Reply to EDS raised by MOEFC&C dated 02.02.2024 for Dhirauli Coal Block

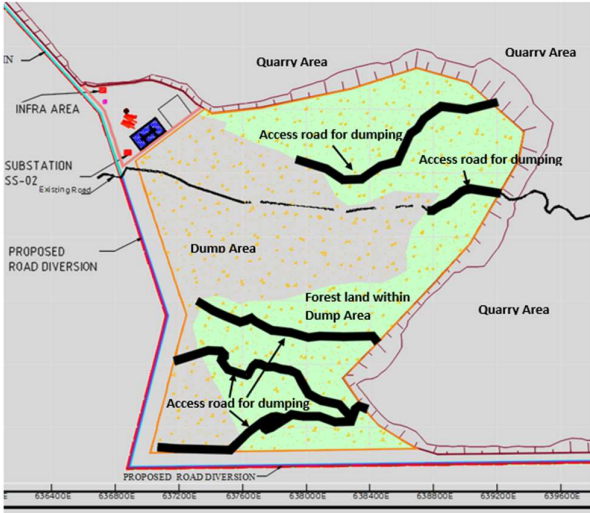
Seam	Extractable Reserves (MT)		Seam	Extractable Reserves (MT)		UG	OC	VIII-Top	-	4.76	VIII-Comb.	-	63.46	VII-Top	-	21.72	VII-Bott.	-	2.58	VII-Comb.	-	93.53	VI	6.56	-	IV	35.08	-	III-Top	63.92	-	II	6.51	-	Total	112.07	186.06	<p>Out of total Extractable reserve (298.13 MT), 62.4% (186.06 MT) is extractable by Open cast method only and remaining 37.6% (112.07 MT) will be extracted by Underground method.</p> <p>The total lease area of opencast mining is inclusive of underground mining and requires no additional land on account of underground, separately.</p> <p>The component wise KML file is uploaded in Parivesh portal .</p>	
Seam	Extractable Reserves (MT)																																									
Seam	Extractable Reserves (MT)																																									
	UG	OC																																								
VIII-Top	-	4.76																																								
VIII-Comb.	-	63.46																																								
VII-Top	-	21.72																																								
VII-Bott.	-	2.58																																								
VII-Comb.	-	93.53																																								
VI	6.56	-																																								
IV	35.08	-																																								
III-Top	63.92	-																																								
II	6.51	-																																								
Total	112.07	186.06																																								
5	As per DSS analysis the proposed area is falling in Inviolate or In High conservation zone value (HCV) with majority area falling in Very Dense Forest category. The state shall	The Ministry of Coal, Govt of India vide Order number NA-104/7/2020-NA on dated 03.03.2021 allotted the Dhirauli Coal Block to M/s Stratatech Mineral Resources Pvt Limited through auction. Out of 1397.54
